**Project Address:** 2107-2249 Sherman Avenue (Aldermanic District 12, Alder Palm)

**Application Type:** Demolition and Conditional Use

**Legistar File ID #:** [39483](#)

**Prepared By:** Heather Stouder, AICP, Planning Division  
Report Includes Comments from other City Agencies, as noted  
**Note: The recommendation has been corrected in this version**

**September 16 Revision – Corner Element**

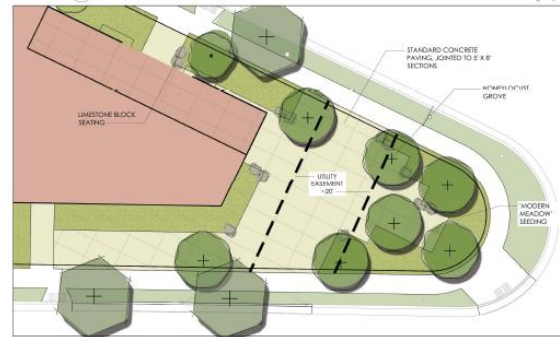
- The corner element has been reconfigured and simplified architecturally, and is now proposed as a solid three-story brick element from the ground up, with a 60-foot stepback before increasing in height to a four-story brick element. The building face has been shifted to approximately 60 feet from the property line at the acute corner, 15 feet from Fordem Avenue, and 8.5 feet from Sherman Avenue. With the setback and stepback combined, the four-story portion of the building begins approximately 120 feet back from the corner of the site. (See comparison below.)
